ECE/TRANS/WP.29/GRSG/2008/14
11 April 2008

Regulation No. 46
(Devices for indirect vision)

Proposal for amendments to the Regulation

Submitted by the experts from the International Motorcycle Manufacturers ^{*/}

Figure 2: Example of rear view mirror bending-test rig

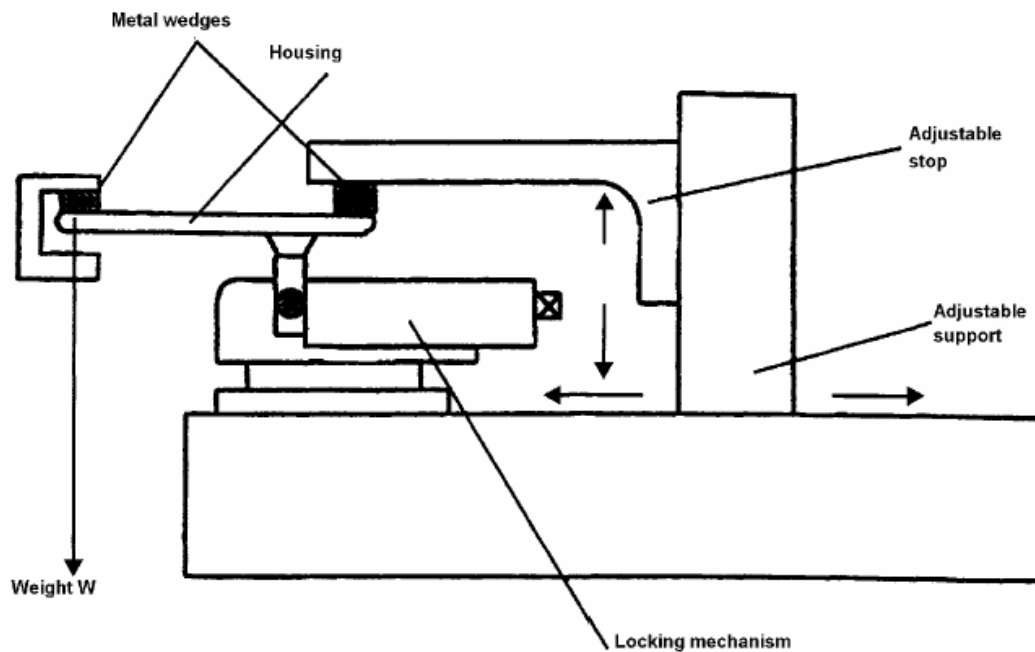
"6.1.3.2.3. **Bending test on the protective housing attached to the stem (Class VII)**

6.1.3.2.3.1. Description of test

The protective housing is placed horizontally in a device in such a way that it is possible to lock the attachment support adjusters firmly. In the direction of the largest dimension of the housing, the end closet to the point of attachment on the adjuster for the support shall be immobilized by a 15 mm-wide rigid stop covering the entire width of the housing.

At the other end, a stop identical to the one described above is placed on the housing so that the specified test load can be applied to it (Figure 2).

The end of the housing opposite to that where the force is exerted may be locked rather than held in position as shown in Figure 2.

6.1.3.2.3.2. The test loading shall be 25 kilograms and shall be maintained for one minute."

Figure 10: Field of vision of Class VII mirrors"

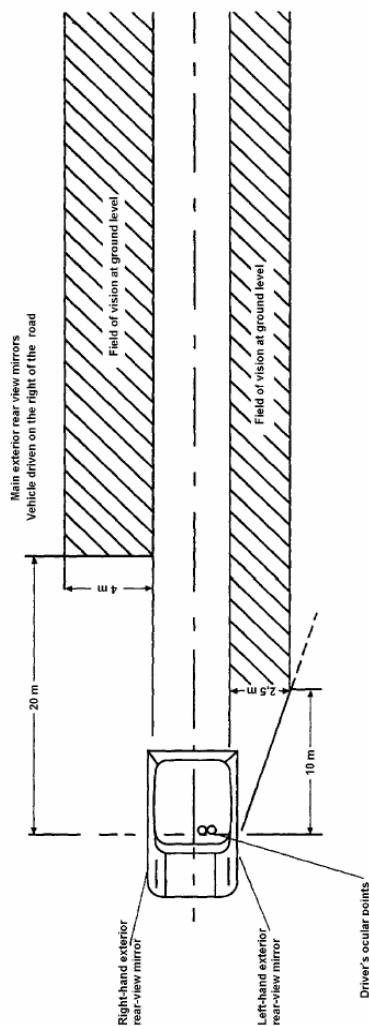
"15.2.4.7. L-category mirror (Class VII).

15.2.4.7.1. Exterior rear-view mirror on the driver's side

The field of vision must be such that the driver can see at least a 2,50 m wide, flat, horizontal portion of the road, which is bounded by a plane parallel to the median longitudinal vertical plane and passing through the outermost point of the vehicle on the driver's side of the vehicle and extends from 10 m behind the driver's ocular points to the horizon (see Figure 10).

15.2.4.7.2. Exterior rear-view mirror on the passenger's side

The field of vision must be such that the driver can see at least a 4 m wide flat, horizontal portion of the road which is bounded by a plane parallel to the median longitudinal vertical plane passing through the outermost point of the vehicle on the passenger's side and which extends from 20 m behind the driver's ocular points to the horizon (see Figure 10).
